Our Ref: 44062-001-01
Your Ref: MCU25/0075

**RESPONSE TO INFORMATION REQUEST
DEVELOPMENT APPLICATION FOR MATERIAL CHANGE OF USE
FOR MULTIPLE DWELLING (81 x DWELLING UNITS)
344-346 ROSS RIVER ROAD, CRANBROOK**

344-350 ROSS RIVER ROAD INFORMATION REQUESTS – RESPONSE TO TRANSPORT AND ACCESS ITEMS

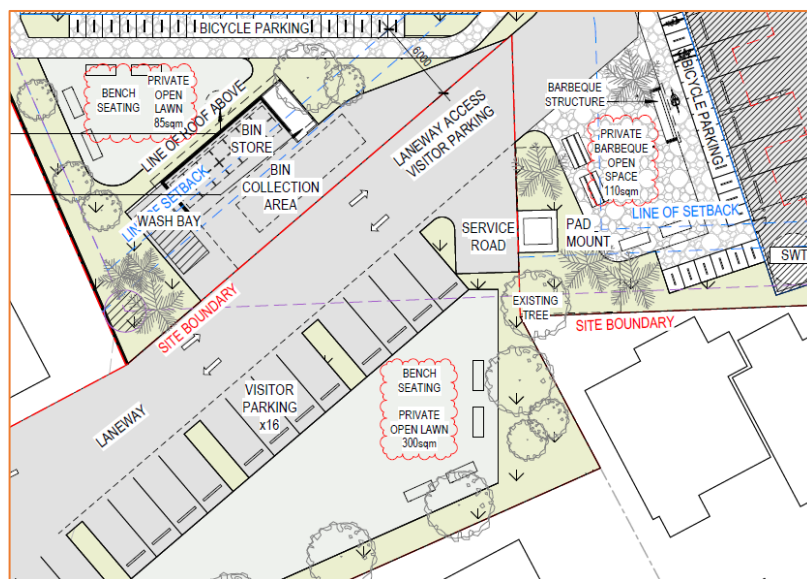
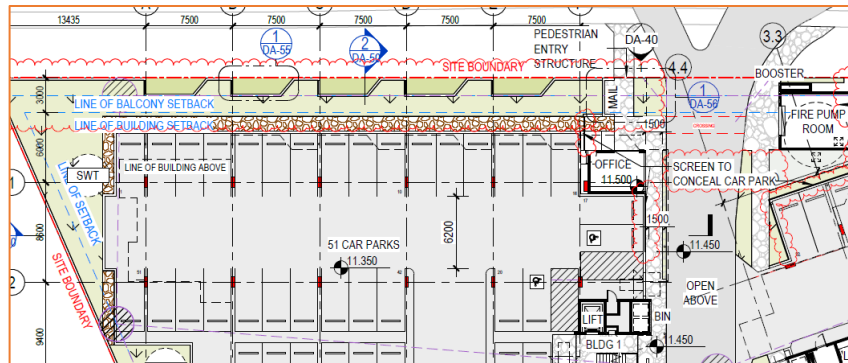
The applicant is requested to provide amended plans incorporating the following design changes to improve the interface and engagement with the Ross River Road frontage:

- *Clear pedestrian pathway access including a structure or gateway from Ross River Road that is separate from the driveway, and connects to an internal pedestrian pathway and communal space;*
- *Consideration of size of the private open space areas and demonstrate that each unit is provided with sufficient area to meet the resident's needs; and*
- *Redesign the ground floor elevation to provide built form elements to activate the street frontage and conceal the car parking on ground level from public view.*

- A clear entry structure is proposed, along with a pedestrian crossing – refer diagram below and **Appendix A**.

- The three areas to the rear of the site are to be designated open space areas. It is proposed that these areas will be embellished with trees and benches and a barbeque with associated structures (e.g. bench seating). Refer to diagram below and **Appendix A**. It is the applicants preferred option to provide barbeque and associated structures as opposed to loud activities such as basketball courts, skateboarding, etc. as mentioned in request item 2.

- It is proposed to activate the street frontage through the form of boundary fence line articulation and materiality. Further, screening to the car park through the vehicle entry is proposed to further conceal it from the street. Refer to below and **Appendix A**.

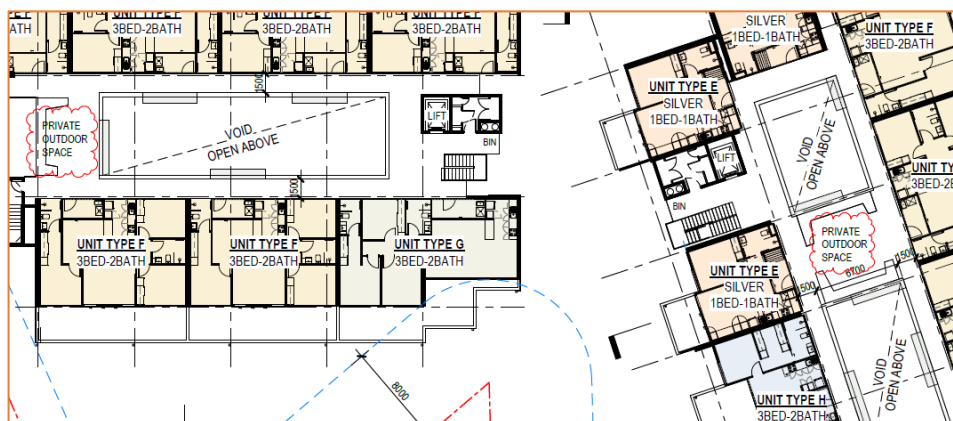
The applicant is requested to provide amended plans demonstrating provision of communal open space to service the proposed development, inclusive of appropriate facilities/embellishments to create flexible, usable spaces for residents.

Introduction of communal spaces on ground level has been demonstrated as a response to request item 1. Further, it is proposed that seating/gathering spaces next to the void for every 2nd level are provided. Refer to **Appendix A**.

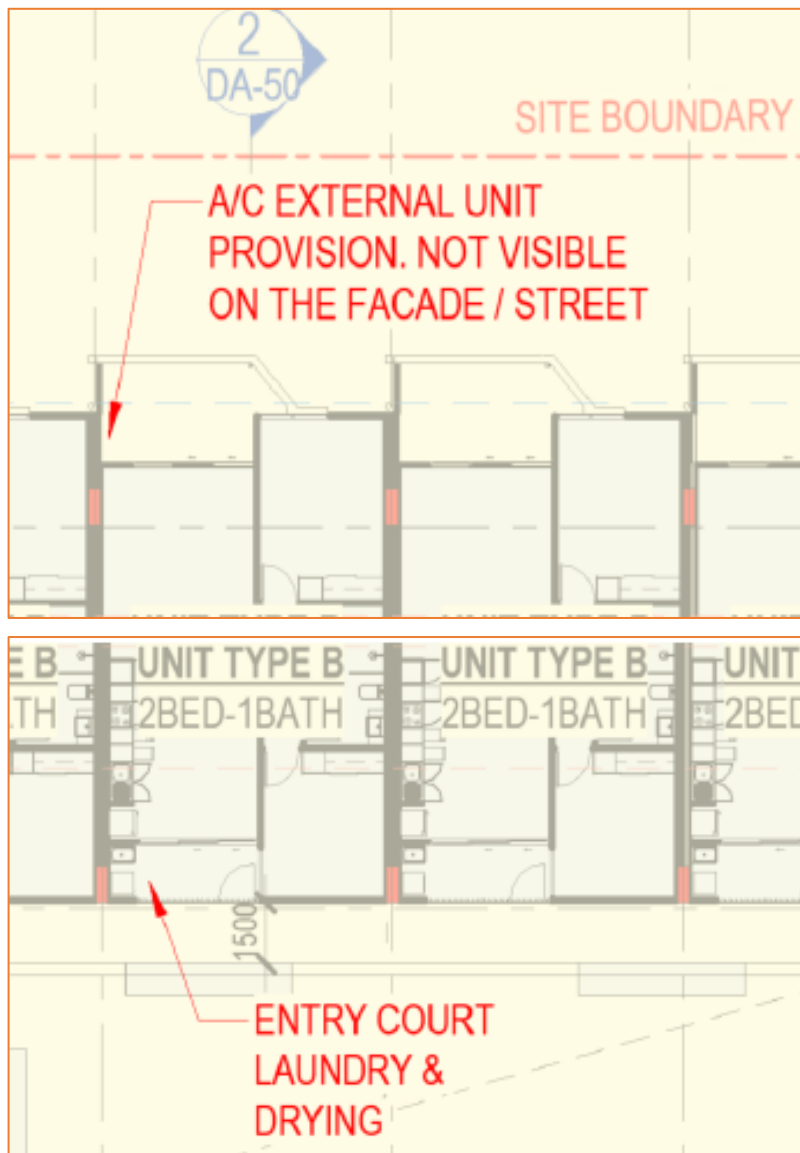
The applicant is requested to demonstrate the location of any utilities such as gas, water tanks or air-conditioning units for each dwelling unit, ensuring these are located outside of proposed private open space. The applicant is further requested to confirm if external clothes drying facilities are proposed and, if so, similarly demonstrate their location.

Air-conditioning units are to be located on the balcony, not visible from the street. Further, clothes drying facilities are located on the unit entry court not visible from public viewpoints. See diagrams below and **Appendix A**.

DRAWING
ROSS RIVER ROAD
PROPOSED ACCESS

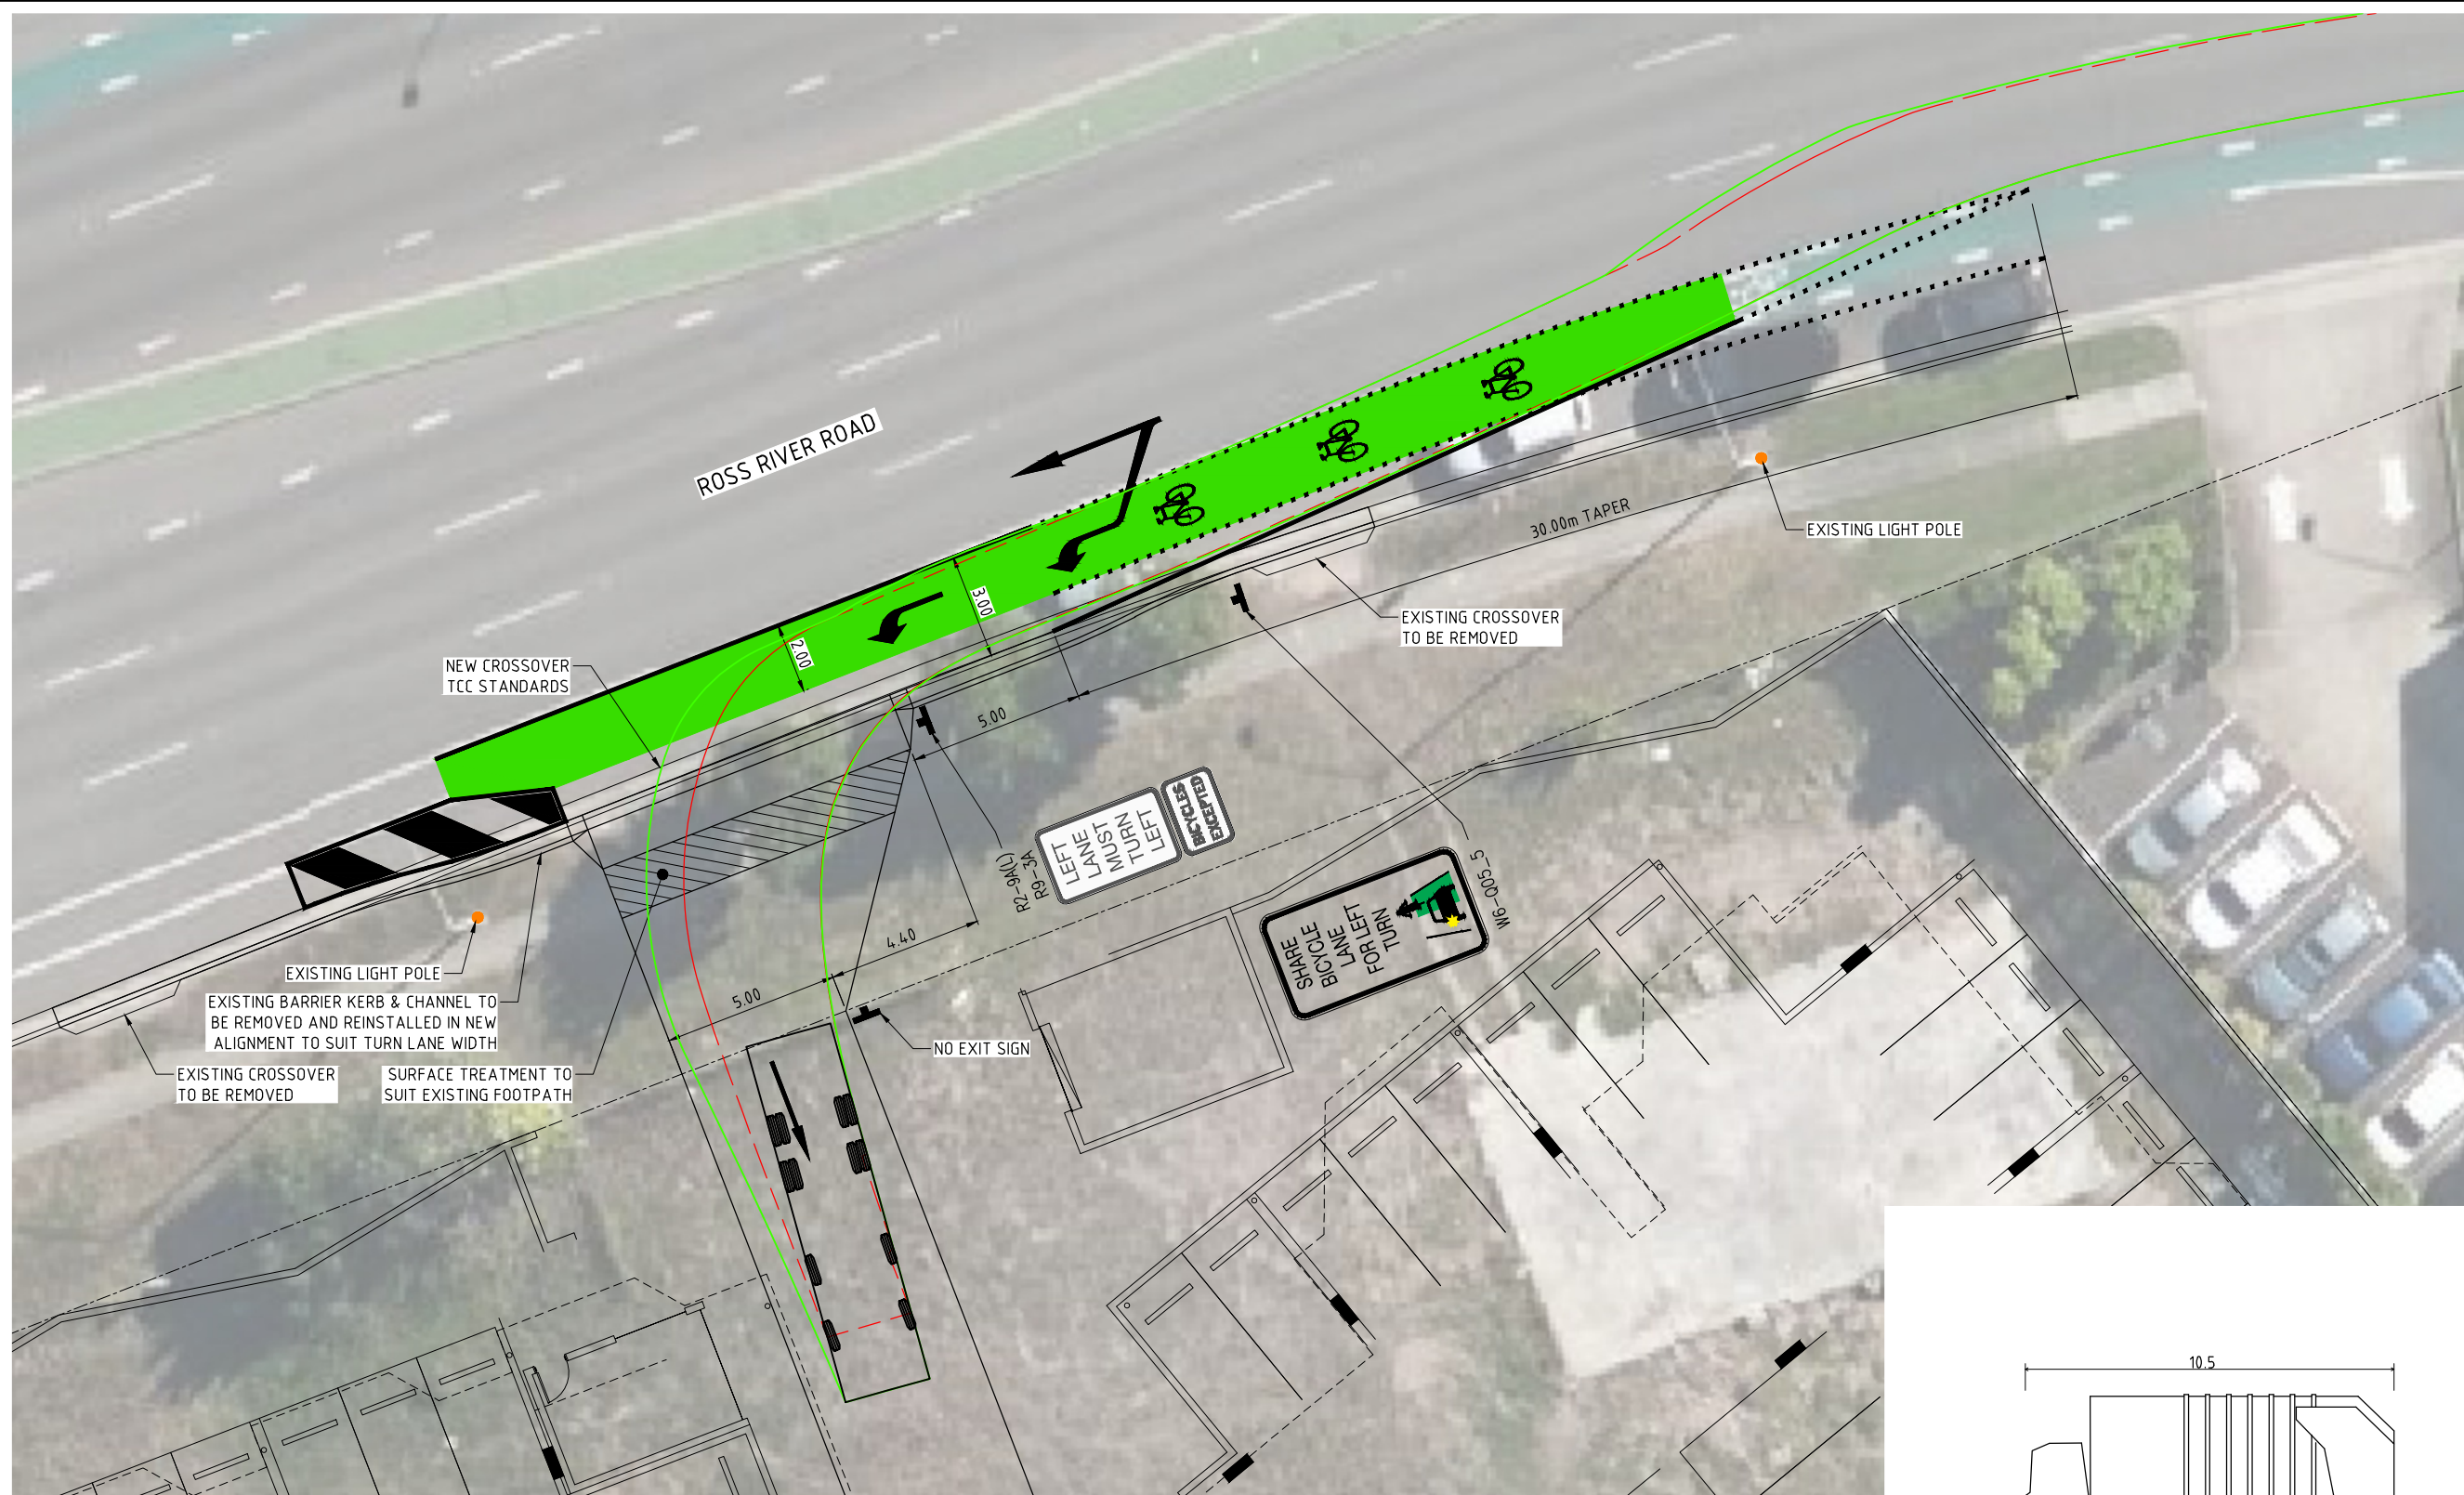
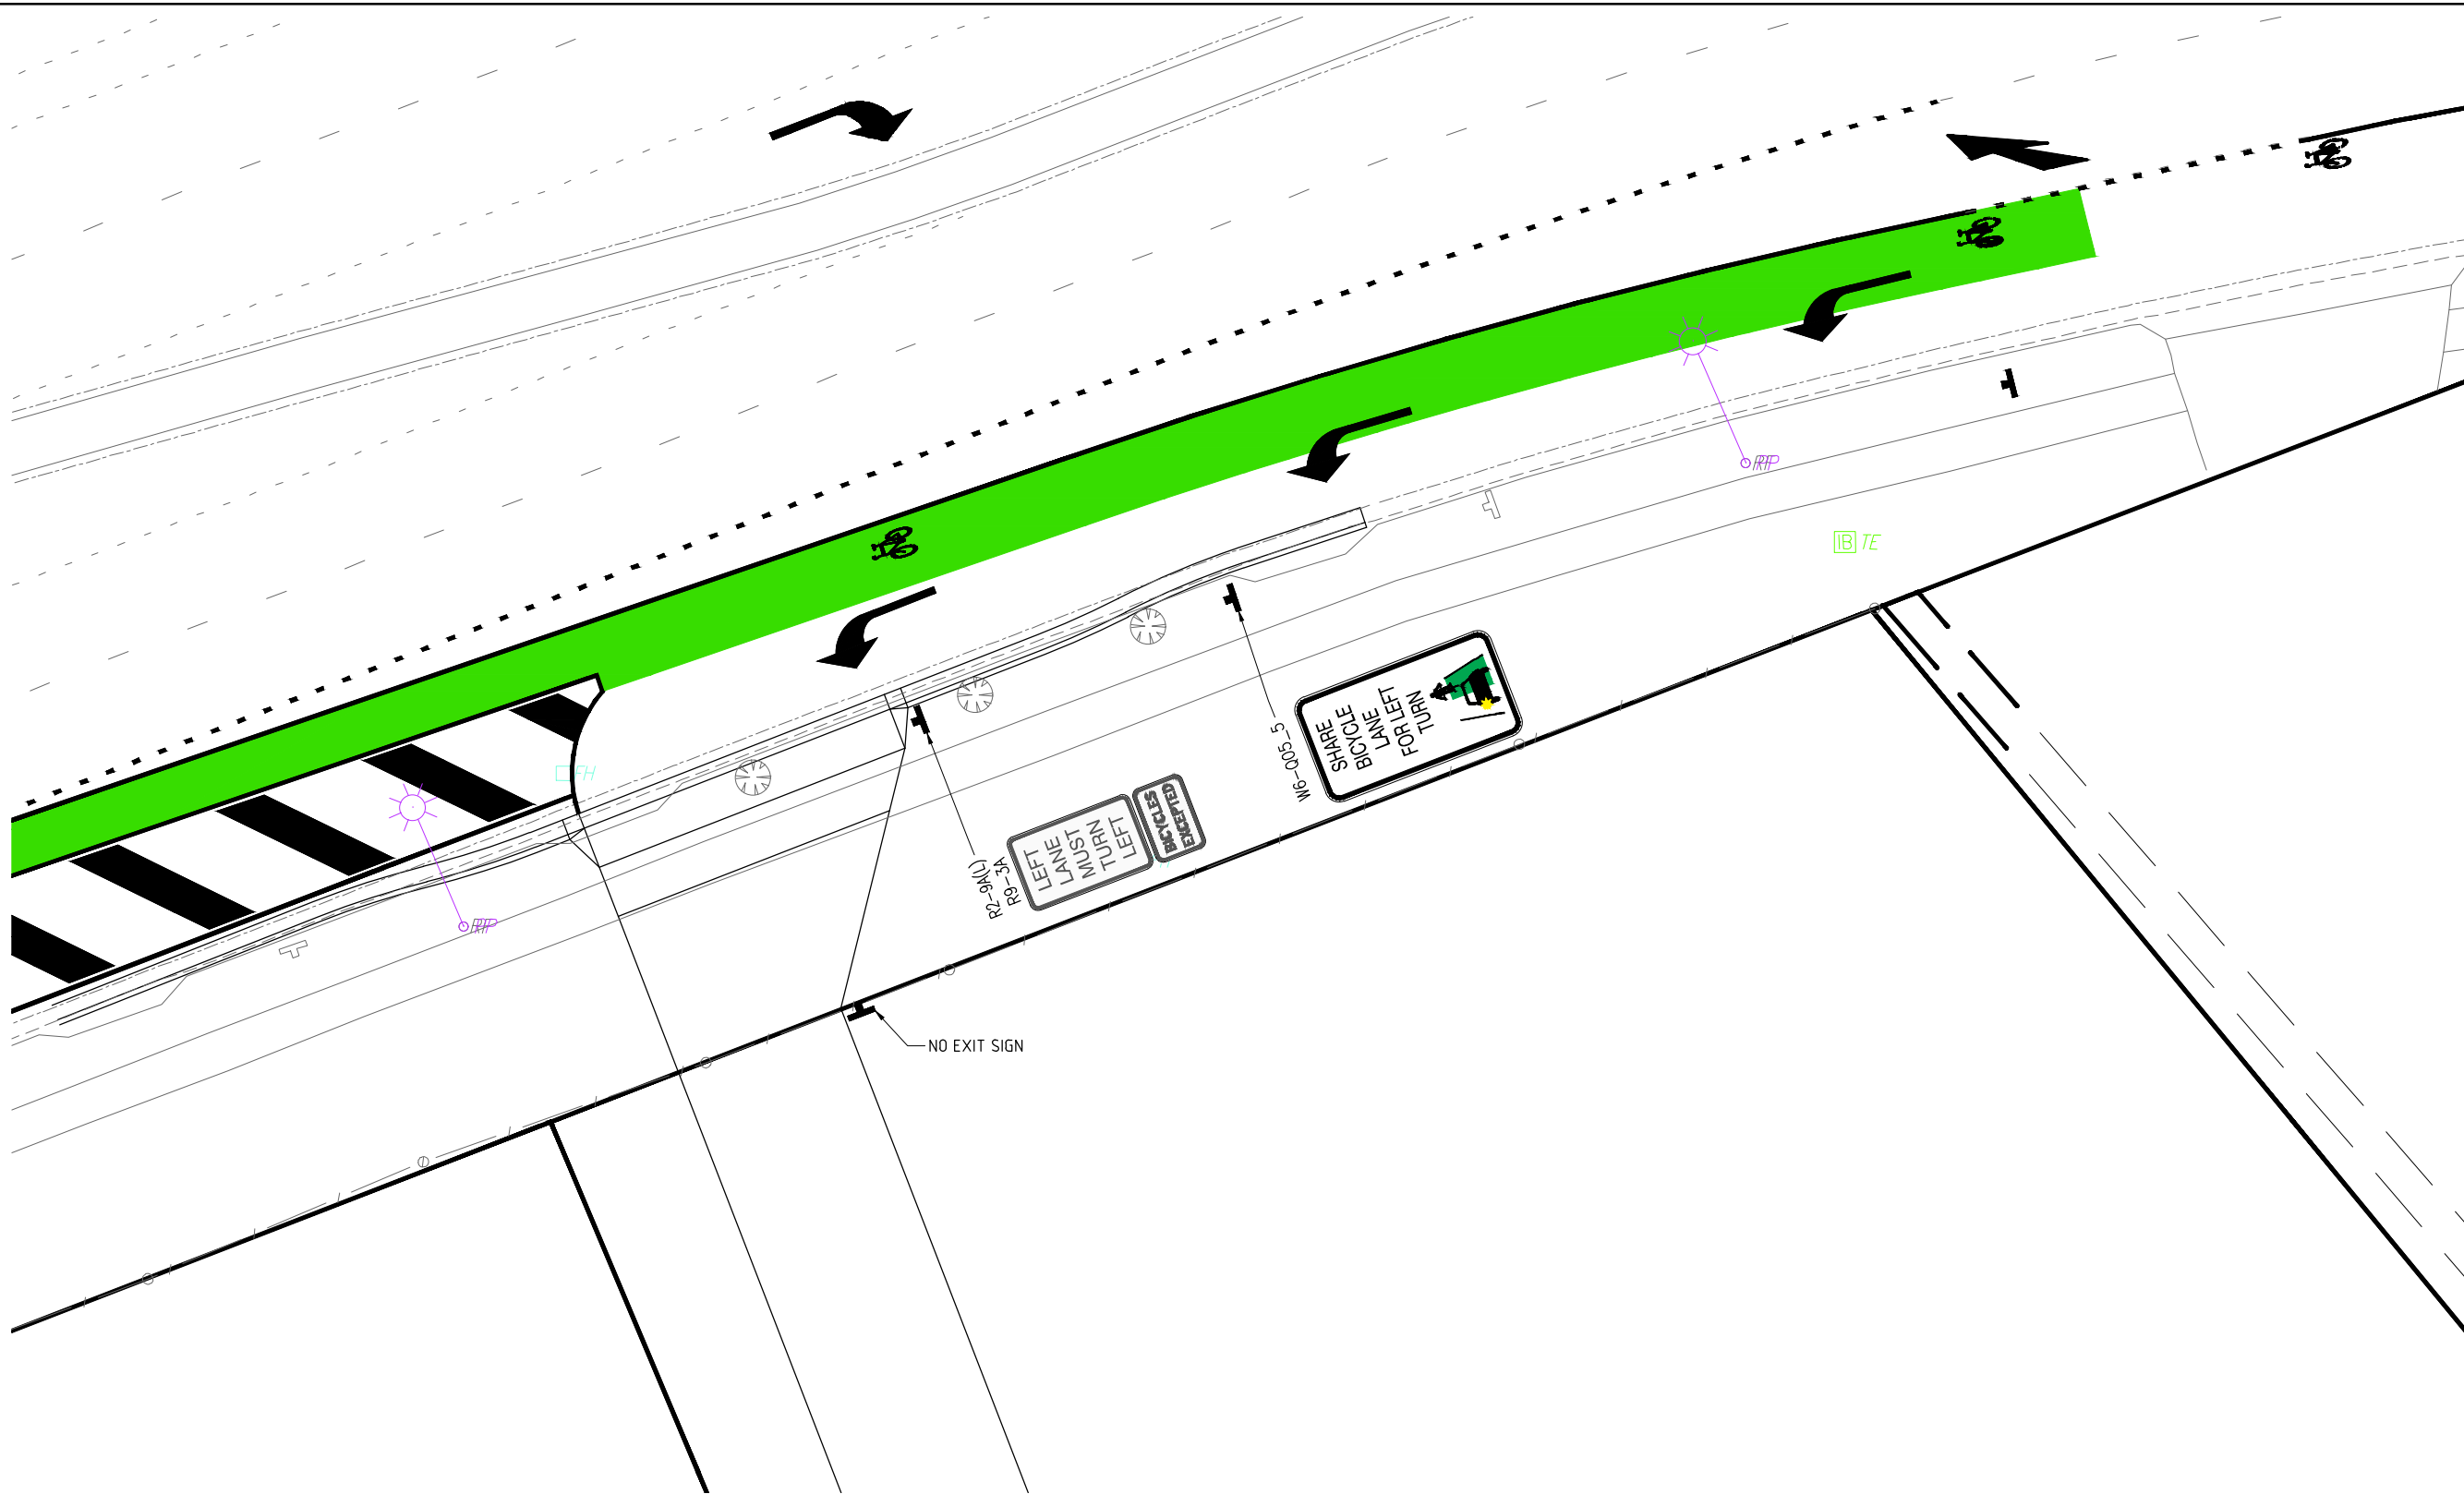
- > TCC Request Item 6 – Albert Street Access
- > SARA Request Item 1:
 - a. Net Delay Assessment
 - b. SIDRA Layouts
 - c. Proposed Access Arrangement
 - d. Driveway Interaction with Acheron Street Intersection Functional Area

- > The previously proposed exit to Ross River Road has been removed from the proposed Ross River Road access arrangement.
- > Entry from Ross River Road provides an auxiliary left turn treatment with a short turn slot (AUL(s) in accordance with the turn warrant assessment documented in Section 5.3.1 of P003620-R01revA.
- > The on-road bicycle lane is designed in accordance with TMR's approved as official traffic sign W6-Q05_2 Retrofit Bicycle Lane in a Left Turn Lane "Unsignalised Intersection". This is the same treatment as proposed by TMR in future road network planning for entry to 340 Ross River Road.
- > The entry driveway will be constructed with vertical deflection that slows approaching drivers in accordance with Section 6.14 of TMR's 2021 guideline.

HURA018-SK8-A shows the proposed Ross River Road access in the context of TMR planning for a westbound merge point (from three into two lanes) at the site's frontage. The planned merge increases the shoulder width available for the on-road bicycle lane and AUL(s) which may allow the W6-Q05_2 treatment to be removed.
